Project: CVHS Fiber Backbone Replacement
Title: Addendum No. 2
Date: January 15, 2020
From: Kelley Howell, PIVOT Architecture
To: Interested Bidders

This modifies the Project Manual, Specifications, and Drawings in accordance with the Invitation to Bid and the Instructions to Bidders as follows:

SHEET TITLE:
**BAYFACE
DETAILS**

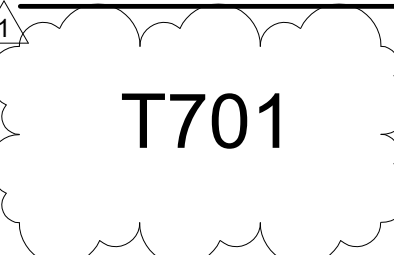
- 1.4.11 Q. Drawing T701, Detail No 3 IDF B1 Bayface (Existing) there is not an FDU enclosure detailed on the bayface detail, will this be a 1-RU or 2-RU FDU and where will it be mounted in the frame?

3 IDF B1 BAYFACE (EXISTING)

A. See updated bayfaces on T701 and T702.
- 1.4.12 Q. Drawings T701 & T702, are the FDU panels on the bayface drawings in the MDF, IDF-C, IDF-E and IDF-F existing or new to be provided?

A. New FDUs are to be provided as part of this contract in all frame locations.
- 1.4.13 Q. Is the legacy multimode fiber to remain in place and incorporated into the FDU panels or is it to be removed as part of this scope of work?
